PUBLIC INTEREST REVIEW FOR GROUNDWATER APPLICATIONS

SUBJECT: Application G- 17916 Supersedes review of 3/24/2015

A. GENERAL INFORMATION: Applicant's Name: Phillip and Lorissa Singhose County: Harney

A1. Applicant(s) seek(s) 11.25\* cfs from 3 well(s) in the Malheur Lake Basin, Lower Silver Creek subbasins Quad Map: Oakerman Lakes / Moon Reservoir

**Greater Harney Valley Groundwater Level Trends  
Oregon Water Resources Department  
April 2015 Draft**

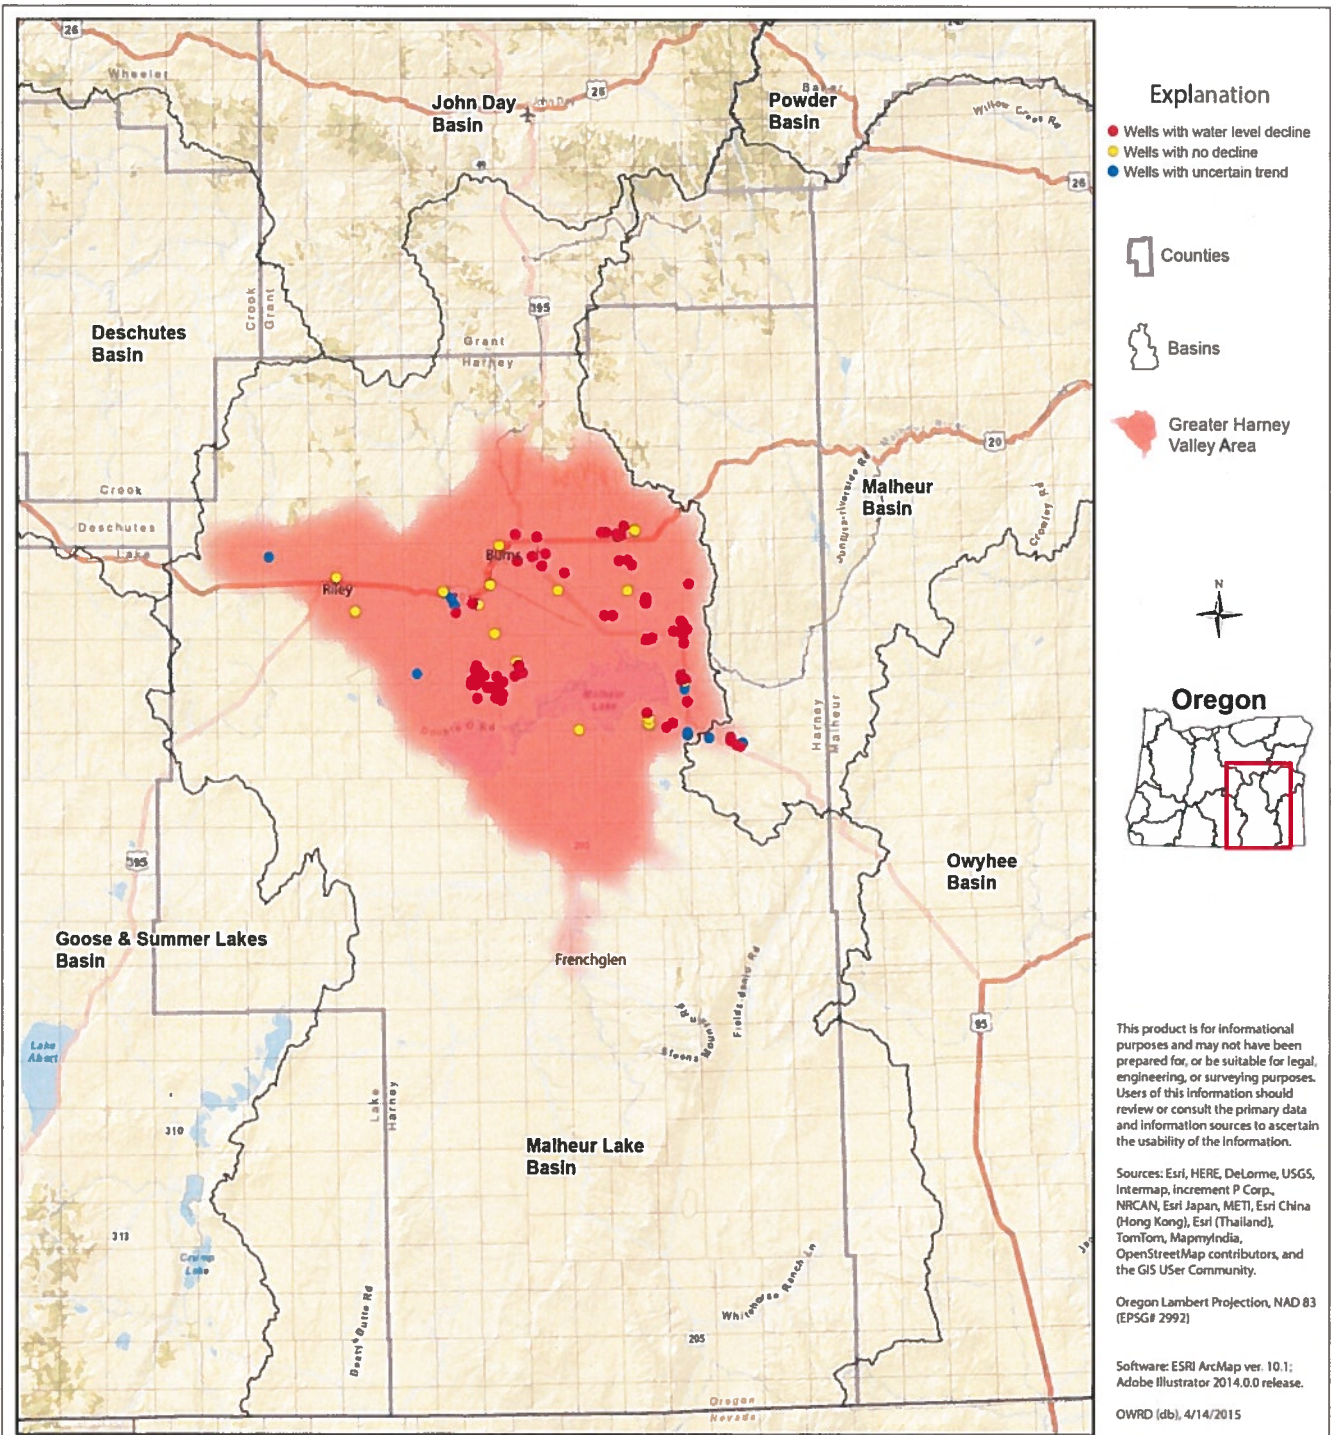
The proposed well(s) for this application is within the greater Harney Valley area where observed groundwater level declines are occurring in most areas (see attached map). The decline indicates that demand for groundwater is exceeding the average annual recharge. An analysis by the Department confirms the volume of groundwater permitted for annual use exceeds the average annual volume of recharge to groundwater. The Department also estimates that approximately 30 percent of the total acreage permitted for groundwater use has yet to be developed. Groundwater development for these acres under already-existing permits will further increase the groundwater level decline rate. Based on the location of the proposed POA(s), the Department finds that the proposed groundwater use will occur from the same groundwater source exhibiting groundwater level declines. Groundwater is therefore determined to be over-appropriated [see OAR 690-400-0010(11)(a)(B)] and the proposed use for this application is not within the capacity of the resource.
